GOVERNMENT OF INDIA
MINISTRY OF ENVIRONMENT, FORESTS & CLIMATE CHANGE

Central Zoo Authority

DATE: 24.06.2015

Subject:- Proposed revised designs for construction of enclosures at Nisargakanya Bahinabai Choudhary Pranisangrahalaya, Pimpri, Maharashtra – regarding

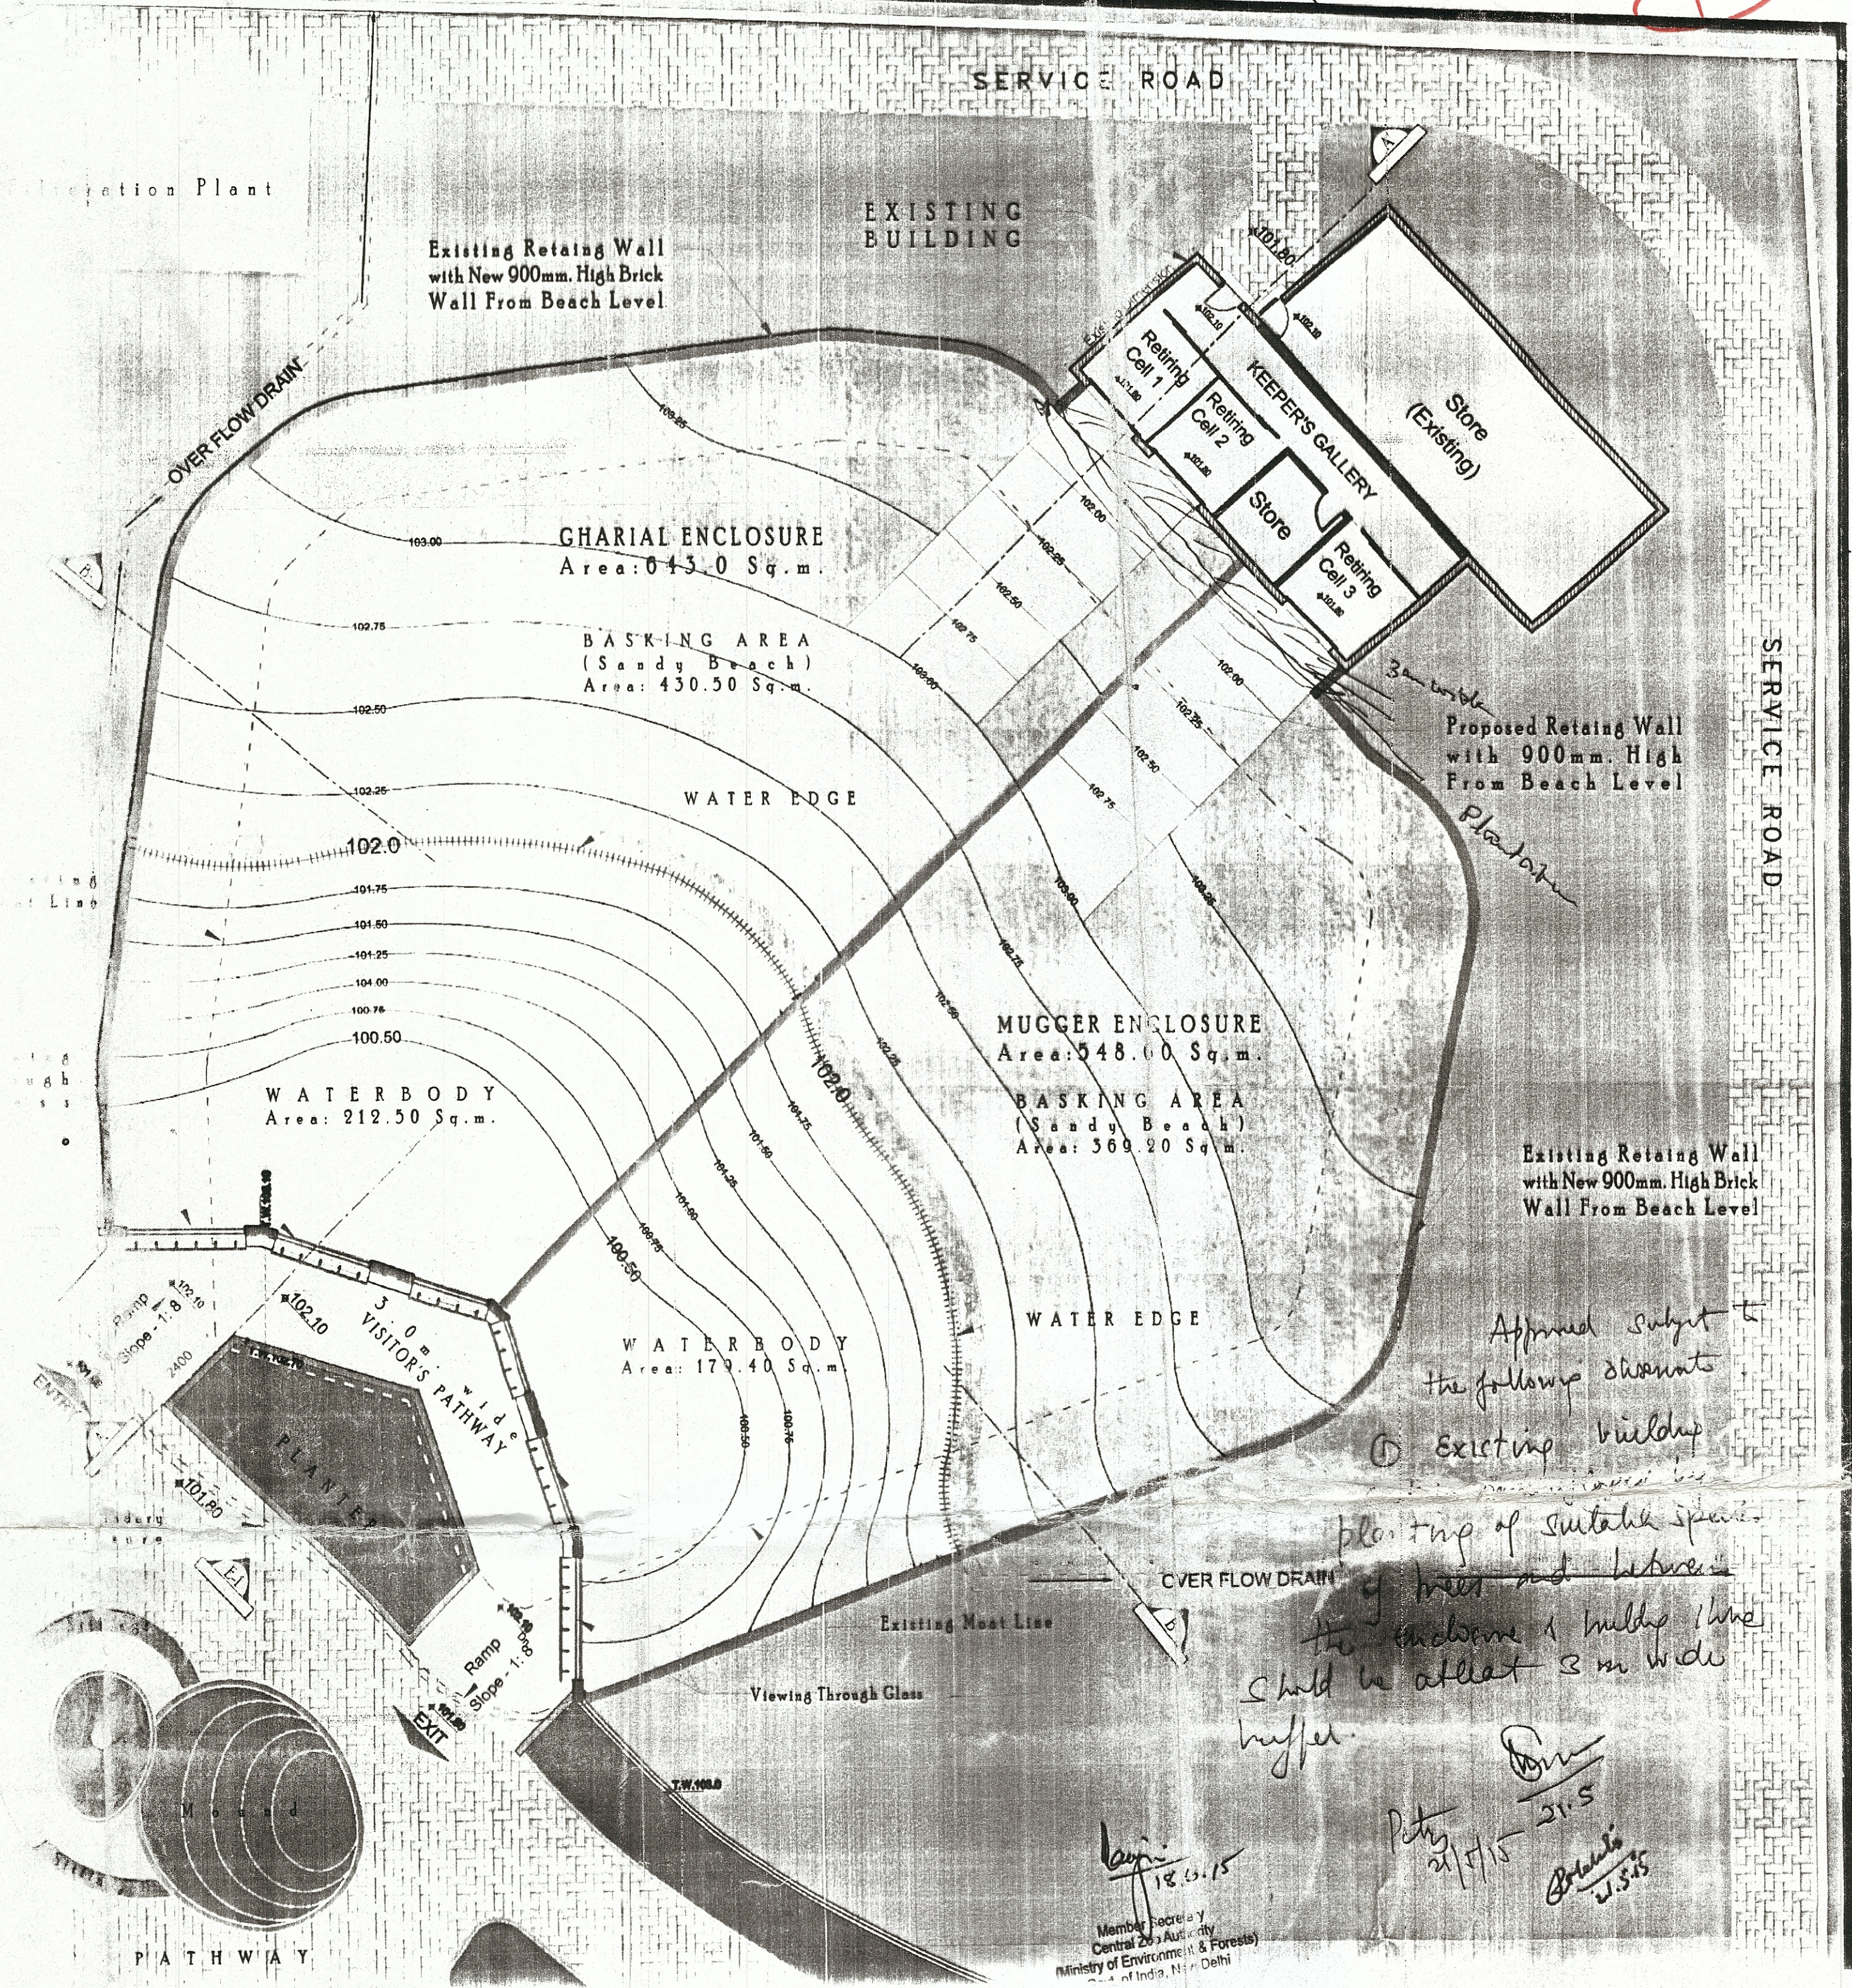
- i. The height of skylight glass from roof should be at least 2.5 feet as indicated.
- ii. The acrylic sheet covering skylight should be of poly carbonate and extend over the side by 1 foot.
- iii. Additional ventilation should be provided on the outer wall of visitors' path/corridor as indicated. There should be an overhang over the ventilation to prevent glare on the viewing glass.

LAYOUT PLAN OF MUGGER & GHARIAL ENCLOSURE

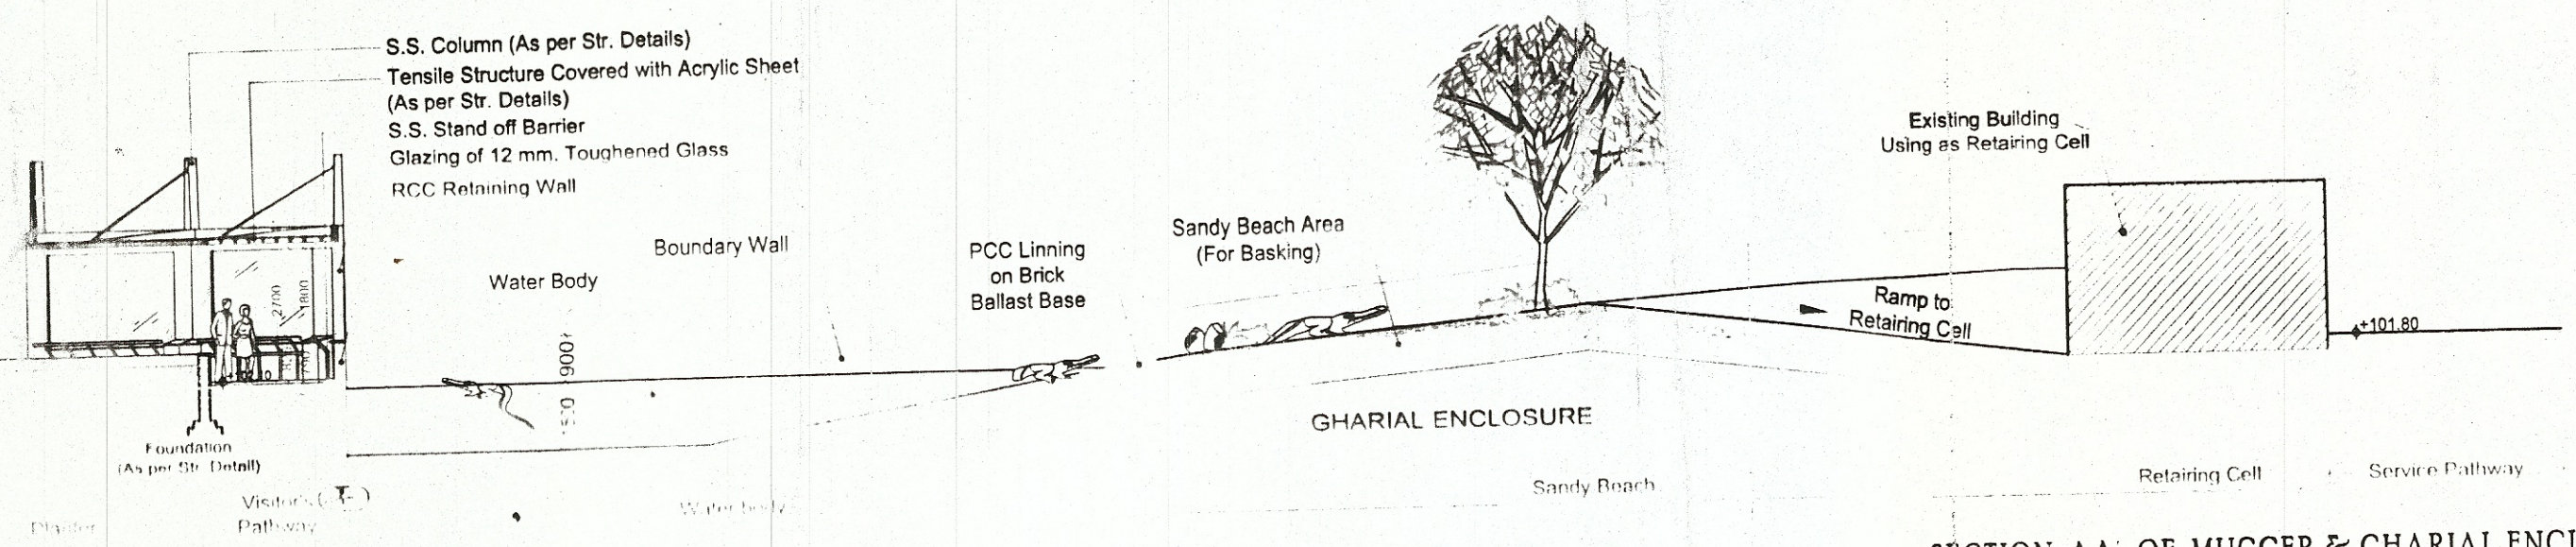
- i. Existing building shall be camouflaged by planting of suitable species of trees.
- ii. There should be a buffer of 3m wide between the enclosure and building.

Approved subject to the following conditions
 1. Existing building
 planting of suitable species of trees and between the enclosure & muggy there should be atleast 3m wide buffer.
